*Proceedings of the Madras Government, Public Works Department,
18th April 1874.*

No. 201. Read the following letter from Lieutenant-Colonel J. H. M. SHAW-STEWART, R.E., Consulting Engineer for Railways, to Colonel G. W. WALKER, R.E., Secretary to Government, Public Works Department, dated Madras, 26th January 1874, No. 55:—

Wire fencing.

Railway Fencing

To show fencing with 4th or lower wire removed.

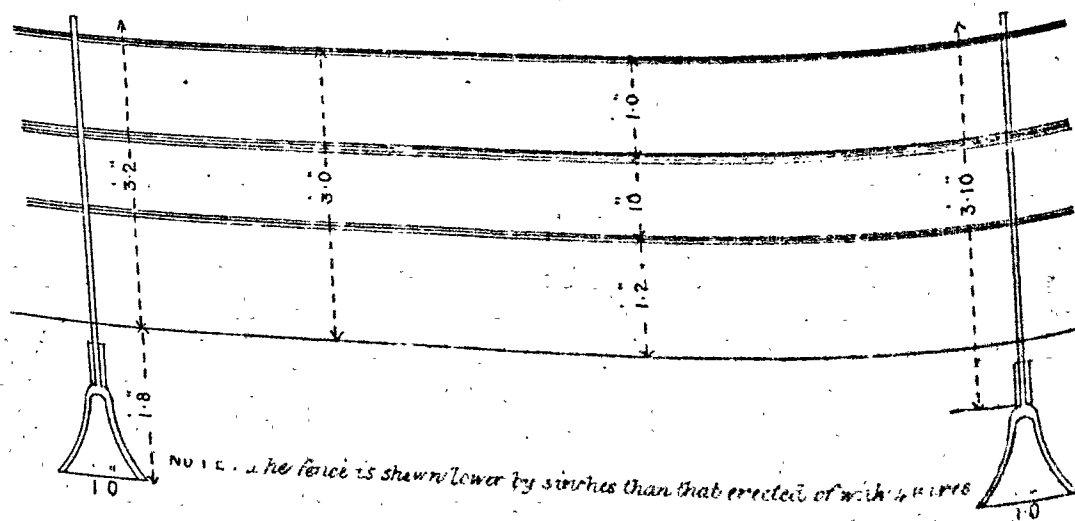
6. I regret that I am unable to support the proposals now brought forward by the authorities of the Great Southern of India Railway. My experience of iron wire fences in this Presidency has satisfied me that 9 inches is the maximum space that ought to be allowed between adjacent wires. On part of the South-West Line of the Madras Railway the fence originally erected was furnished with only three wires, the top wire being 3 feet in height from the ground, and the intervals between the wires being 12 inches. It was, however, found that the country cattle got so easily through this fence that two additional wires were afterwards added, and it now forms an efficient protection against cattle.

The bottom and top wire are placed 8 inches and 3 feet 3 inches, respectively, above the ground, the intervening height is, beginning from the bottoms, divided into spaces of 9, 10, and 12 inches, respectively.

By taking out the bottom wire a space of 17 inches is left through which nothing larger than a sheep or goat can creep. No cows or bullocks could come through that space. With the four wires at present in use sheep and goats easily push through the fence. It appears, therefore, that with the three wires, I propose the large cattle will still be kept out, while we shall not be in any worse position as regards the smaller animals. I would therefore commence that the sanction of Government be asked to taking the bottom wire out of the existing wire fence on the line, and that we be permitted to put a three wire fence where necessary on the southern extension. If this is done a considerable saving to the Capital Account will result, because the bottom wire taken out of the existing fences will go a long way towards fencing the Carnatic Railway, as well as supplying all that is likely to be required on the southern extension of this railway.

The space of 17 inches left by taking out the bottom wire can be reduced to 14 inches by sinking the fence a little, that is, instead of keeping the top wire 3 feet 3 inches high, make it 3 feet, which would, I think, suffice in most cases along our line of country.

IN reply to your letter, dated the 29th ultimo, No. 5,215, I have the honour to inform you that, in addressing the Government of India in March 1873, the Government of Madras expressed their opinion that an iron wire fence, suitable for the exclusion of cattle, ought to consist of not less than four wires, and that the height of the top wire above the ground ought to be not less than 3 feet 6 inches. Mr. Logan's proposal to reduce the number of wires and the height of the fence cannot, therefore, be sanctioned.

India Railway that wire fences of the dimensions proposed by him are sufficient for the exclusion of cattle; but as in the Resolution recorded with G. O., No. 2,790, dated 3rd November 1871, the Government of India contemplate the issue of final orders on the question after a consideration of the circumstances of all Guaranteed Railways, the papers will be laid before that Government in continuation of the correspondence ending with letter, No. 2,719, dated 7th November 1873. Having in view, however, the comparative inefficiency of the best wire fences, His Excellency the Governor in Council would suggest, for the consideration of the Government of India, whether the Cow-catcher of America might not be advantageously adopted. Its use is believed to be attended with great success in that country.

to show-fencing/with 2 to 4 lower were removed

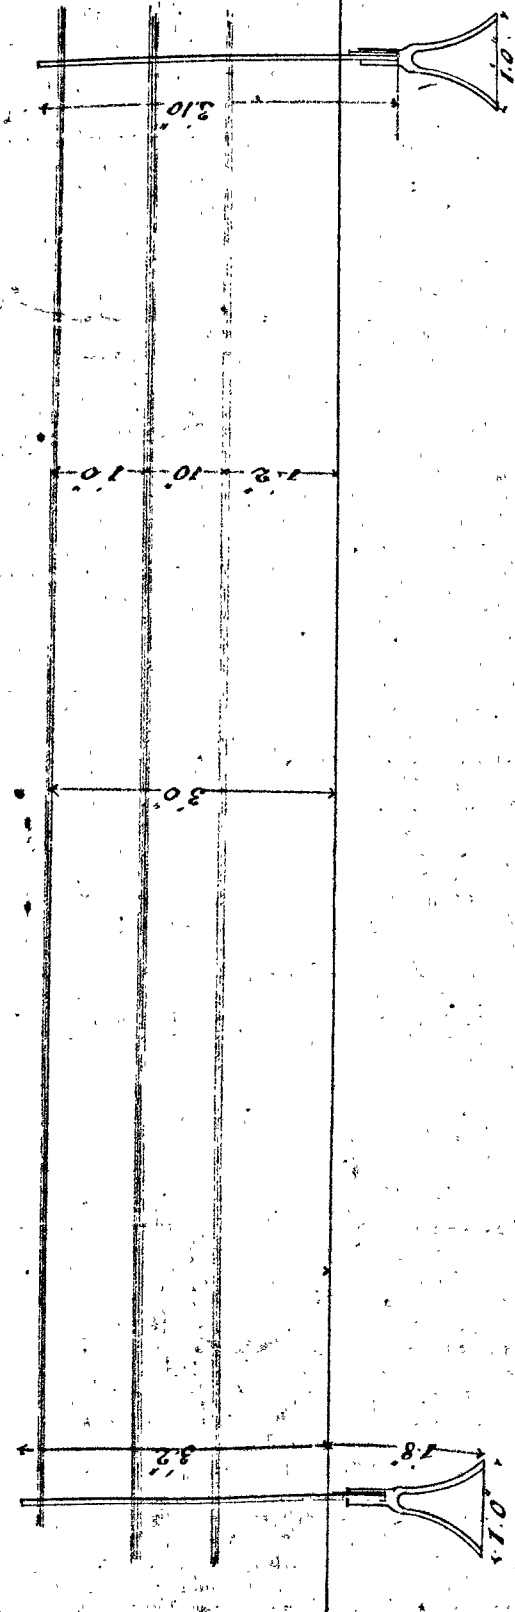
The bottom and top wire are placed 8 inches and 3 feet 3 inches respectively above the ground; the intervening height is, beginning from the bottom, divided into spaces of 9, 10 and 12 inches respectively. By taking out the bottom wire a space of 17 inches is left through which nothing larger than a sheep or goat can creep. No cows or bullocks could come through that space. With the four wires as present in use sheep and goats easily push through the fence. It appears therefore that with the 3 wires, I propose the large cattle will still be kept out while we shall not be in any way poorer as regards the smaller animals. I would therefore recommend that the sanction of Government be asked to taking the bottom wire out of the existing wire fence on the line and that we be permitted to put a three wire fence when necessary on the Southern Extension. If this is done a considerable saving to the Capital Account, will result because the bottom wire taken out of the existing fences will go a long way towards fencing the Barua Railway as well as supplying all that is likely to be required on the Southern extension of this Railway.

Reduced to 14 Inches by sinking the fence a little, that is
instead of keeping the top wire 3 feet 3 inches high make it 3 ft
which would I think suffice in most cases a long our line of
Country.

Note. The fence is shown lower by 3 inches than that erected of with 2 wires
